TECHNICAL NOTE

Reference: P1047t02v01

Response to Submissions

New Catherine Field Public School, O'Keefe Drive, Oran Park (SSD 9477)

Figure 1: Construction Vehicle Routes

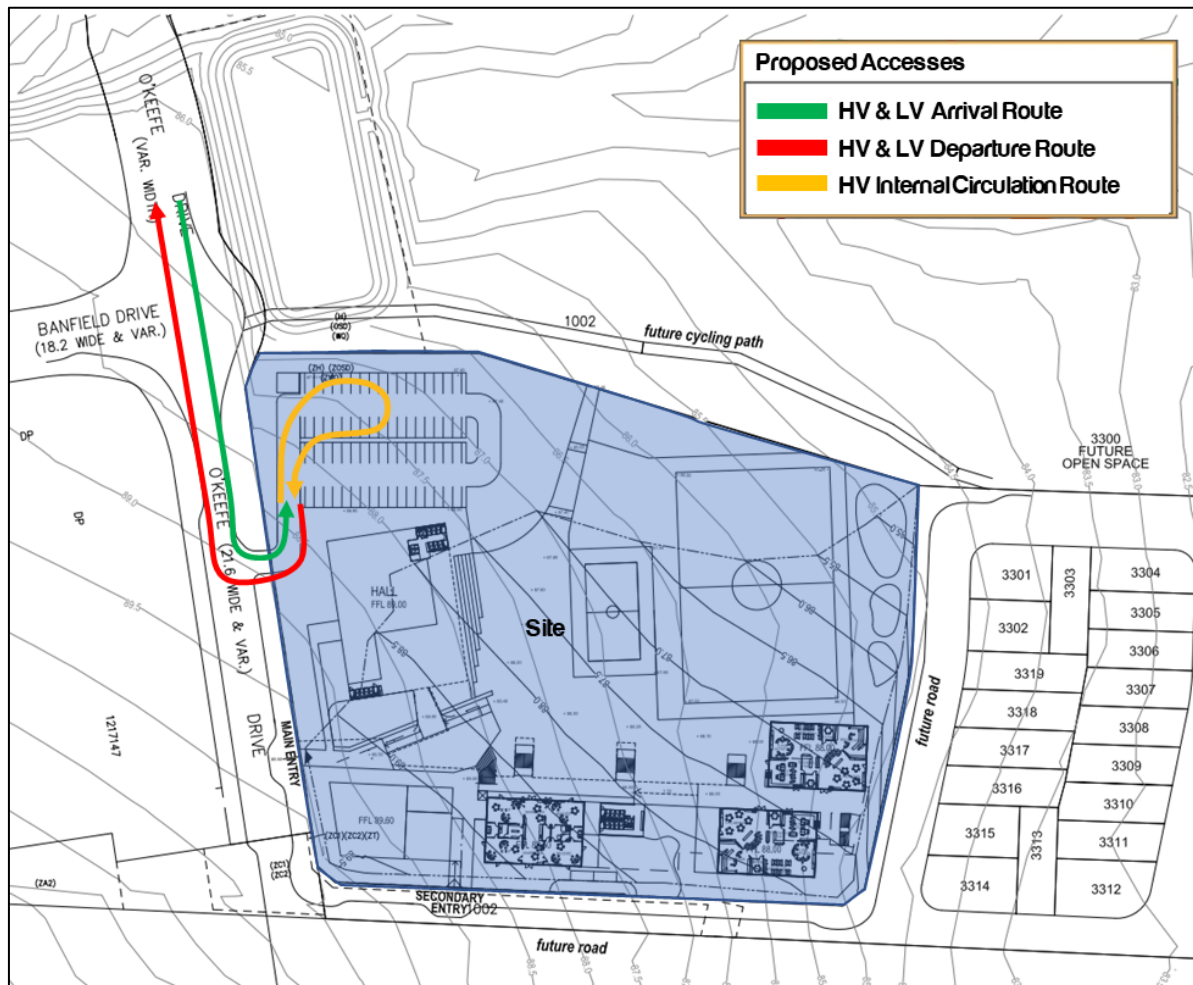
Direct access off O’Keefe Drive is not supported due the potential impact created by turning truck movements in and out of the site close to residential houses. A temporary access point should be located at the southern end of O’Keefe Drive. This will also protect the existing kerb and gutter. In addition to owner’s consent for the subject site, owner’s consent must also be provided for the relevant lot if any works or access is proposed on or from adjoining lots (rather than the road reserve).

This comment appears to be offering conflicting advice—access off O’Keefe Drive is not supported, locate temporary access at southern end of O’Keefe Drive.

O’Keefe Drive is 12.5 metres wide at the northern and southern ends adjacent to the site and the southern end has been identified as an emergency access. Accordingly, the access location shown in Figure 1 are deemed appropriate and acceptable.

Figure 2: Indicative Pedestrian Crossing Locations

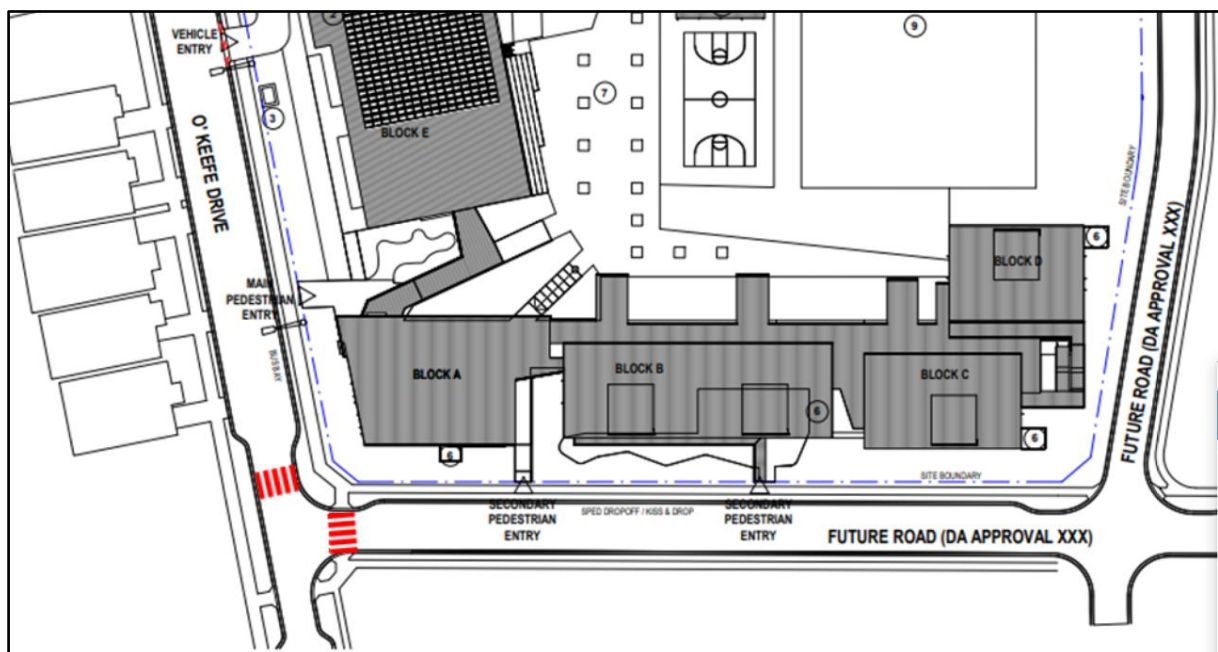
Pedestrian crossings shall be provided. Locations shall be specified. Crossing points should be provided on O'Keefe Drive and crossing points on the southern boundary road.

The above criteria are not known for the school when it will be operational and, whilst the vehicle volumes can be forecast with relative accuracy and may exceed the requirement, the pedestrian volumes and desire lines may not. This is particularly relevant given that the number of possible directions and access desire lines—depending on specific enrolment locations within the catchment—is likely to significantly spread the concentration of pedestrians and therefore reduce the effectiveness and efficiency of a crossing.

Notwithstanding, indicative locations shown in have been shown on the drawings to demonstrate an appropriate and likely location should the warrants be met once the school is operational. The ultimate crossing location should be based on an assessment of enrolment spatial data with consideration of desire lines.

Figure 3: School Peak Period Traffic Generation

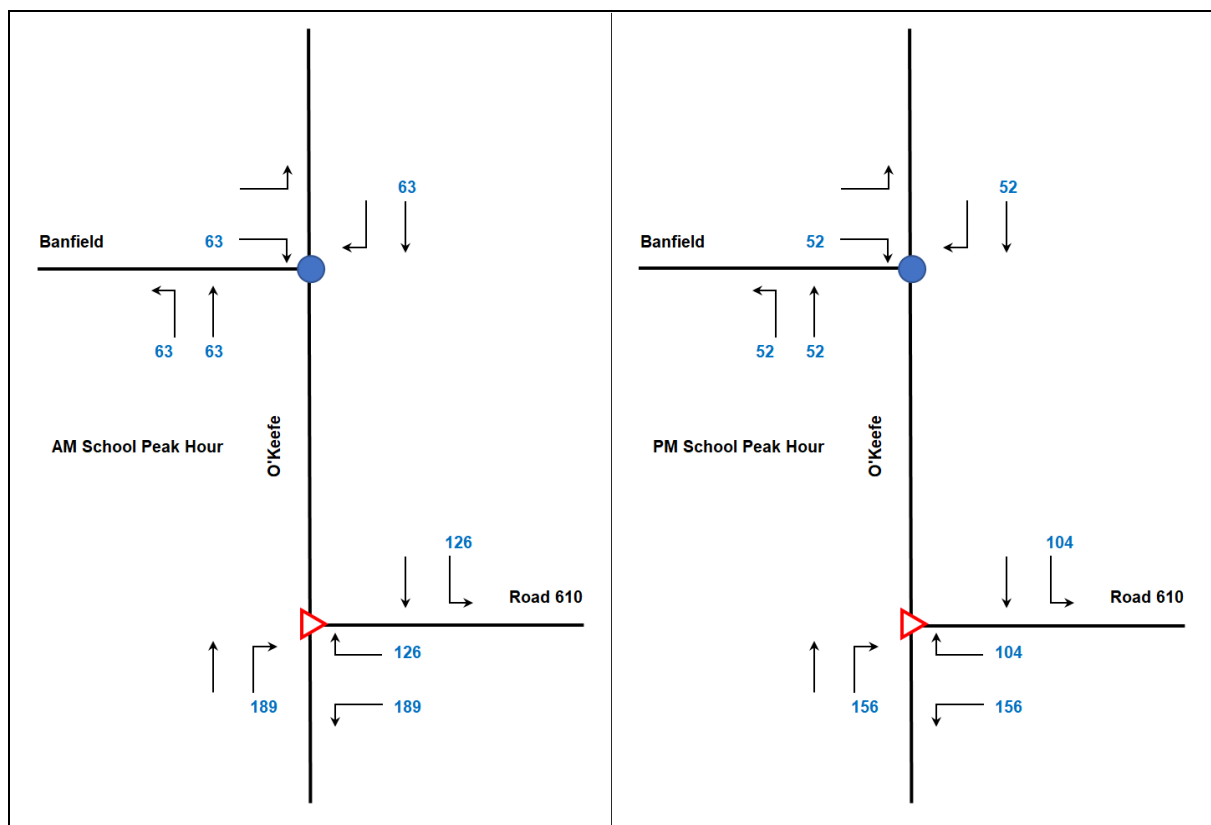
The distribution of peak hour traffic flow has not been discussed or justified.

With reference to sections **Error! Reference source not found.** and **Error! Reference source not found.** of AGTIA, the trip generation of the School during the school peak periods has been assigned to the key intersections of O'Keefe Drive & Banfield Drive, and O'Keefe Drive and Road 610. The results of this assignment are provided in
